Exelon Generation Company, LLC, Early Site Permit Final Safety Evaluation Report Changed Pages

PAGE CONVERSION FROM ACRS MEMO TO FSER

WordPerfect Document Compare Summary

Figure 2.4-7 Water surface elevation in Clinton Lake during the PMF event calculated using the instantaneous-translation level-pool routing method

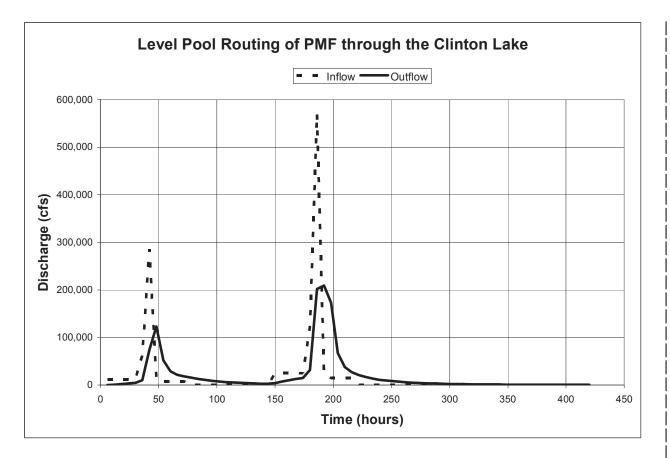
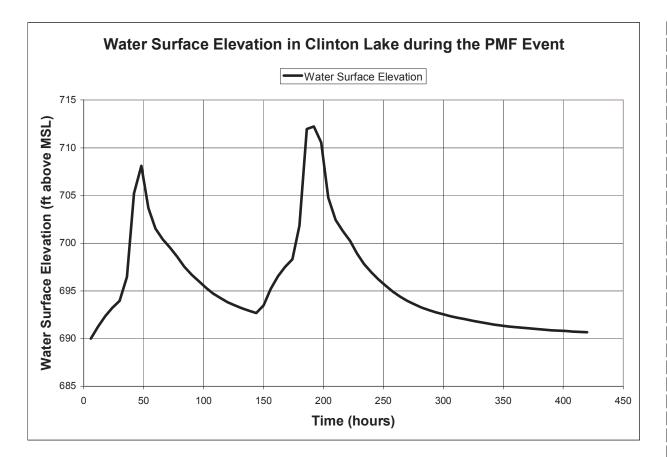
The staff performed the staff assumed that water would spill along the entire dam face; the staff used a weir equation to compute the resulting discharge.

<u>Results generated from the conservative, instantaneous translation,</u> level pool routing that resulted inmethod produced the reservoir inflow-outflow sequence shown in Figure 2Figure 2.4-8-6 of this SER. Figure 2Figure 2.4-9-7 of this SER shows the corresponding reservoir water surface elevations. The staff estimated athe maximum reservoir elevation hydrostatic (stillwater) water surface elevation using this extremely conservative and bounding approach to be 712.2 ft MSL.

Figure 2.4-8 Inflow and Outflow Hydrographs for Clinton Lake during the PMF Event using the HEC-HMS model and the seven sub-basins + lake method

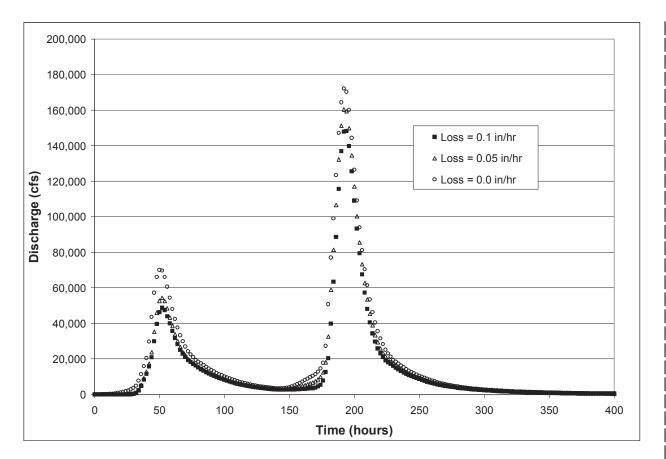
A second analysis was performed by staff using the HEC-HMS Version 3.0.0 computer code. The watershed was divided into eight sub-areas (Clinton Lake plus seven sub-basins) in the same manner as Revision 4 of the SSAR and with the following sub-areas: 1) Salt Creek headwater = 126.8 mi², 2) Salt Creek local area northeast = 5 mi², 3) Salt Creek local area northwest = 16.3 mi², 4) Salt Creek local area southeast = 6.2 mi², 5) Salt Creek local area southwest = 8.2 mi², 6) North Fork headwater = 111 mi², 7) North Fork local area = 15 mi², and 8) Clinton Lake area = 7.6 mi². The basins were connected together in the model so that outflow from the basins immediately entered the lake. This is a conservative assumption since the flow is not routed.

The Clinton Lake inflow hydrograph was estimated using the unit hydrograph approach. Synthetic unit hydrographs were developed to determine the runoff from each sub-basin area. The storm hydrograph entering Clinton Lake was computed based on two-hour unit hydrographs for each sub-basin. An antecedent storm equal in volume to 50% of the PMP, followed by three days of no rainfall, and followed by the full PMP volume (Table 2.4-5) was applied to the Clinton Lake watershed. In addition, the PMP used in the staff's analysis had a total volume of 28.7 in., which is more conservative compared to the applicant's value of 27.8 in. One of the key parameters in the synthetic unit hydrograph method is the lag time. Values of lag times used by the applicant were based on limited published watershed data. The lag times used by the applicant and the staff ('standard lag' Table 2.4-6) in the HEC-HMS model were as follows: 1) Salt Creek headwater = 12.3 hrs, 2) Salt Creek local area northeast = 1.1 hrs, 3) Salt Creek local area northwest = 2.6 hrs, 4) Salt Creek local area southeast = 1.4 hrs, 5) Salt Creek local area southwest = 1.7 hrs, 6) North Fork headwater = 11.3 hrs, and 7) North Fork local area = 2.5 hrs. The selected lag values approximate those developed in Mitchell (1948) and the CPS USAR, although for the present analysis seven watershed sub-areas were used so corresponding values are not directly comparable. Since recent direct field data are not available, the lag time values are subjective. The staff appreciates the empirical nature of these coefficients and of the SCS method in general, which is generally not advised for use for areas larger than 2,000 ac (NOAA, 2006). To test the overall range of Clinton Lake PMF water surface elevations, the staff varied the lag time by shortening and increasing the lag time by 10 percent. Maximum Clinton Lake PMF water surface elevations are shown in Table 2.4-6 for these scenarios.

A second key parameter in the PMF computation method is the infiltration loss. The staff evaluated model sensitivity by reducing the constant loss parameter used by the applicant (0.1 in/hr) first by half (0.05 in/hr) and then eliminating infiltration altogether (0.0 in/hr loss). Computed time series of Clinton Dam outflow and Clinton Lake water surface elevation during the storm event are shown in Figure 2.4-8 and Figure 2.4-9, respectively. The maximum Clinton Lake PMF water surface elevations for this range of infiltration loss parameter values are shown in Table 2.4-6.

Figure 2.4-9 Water surface elevation of Clinton Lake during the PMF event using the HEC-HMS model and the seven sub-basins + lake method

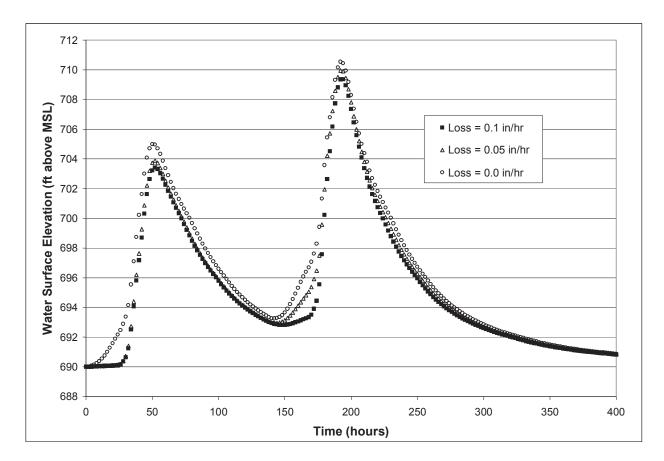
The third analysis examined by staff also utilized HEC-HMS; however the watershed was divided into five sub-basins. Unit hydrographs following Mitchell (1948) and discussed in the CPS USAR were used. These unit hydrographs were made more conservative by shortening the time to peak by 33% and increasing the peak discharge by 20%. The Clinton Lake watershed was subjected to the same 50 percent PMP volume antecedent storm followed by the full PMP volume (Table 2.4-5) as the second analysis. For this analysis, the initial loss and constant loss rate were both set to zero. As in the second analysis, the routing from the five sub-basins to the Clinton Lake was instantaneous (no routing) and the PMP volume was 28.7 in.; both of which are conservative assumptions. The resulting maximum water surface elevation of Clinton Lake during the PMF was 710.6 ft MSL.
